TB 55-2840-248-20-17

TECHNICAL BULLETIN

T700 SERIES ENGINES

CHANGE
NO. 1

Figure 10.1 (T700) Determining Torque Value (TTV) for UH-60A.

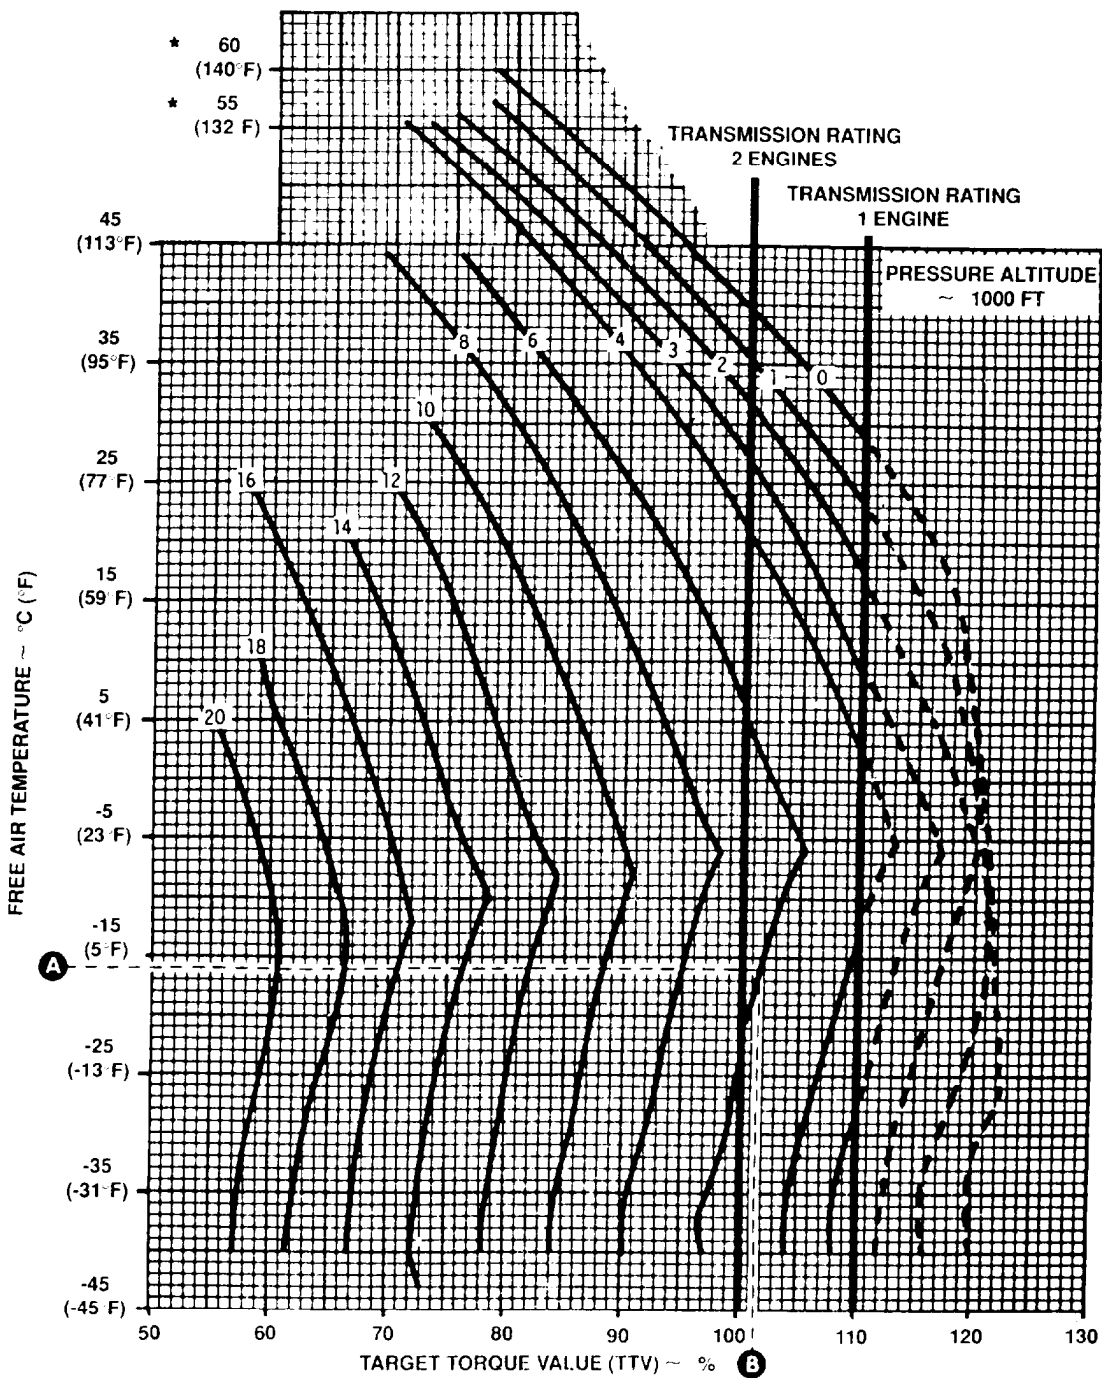
- a. Figure 10.1, Determining Target Torque Value for UH-60A, has been revised to reflect extreme free air temperature (above 113°F or 45°C).
- b. On removal of engine for performance recovery, the following guidance is provided to ensure that once reassembled, satisfactory engine power will be available.
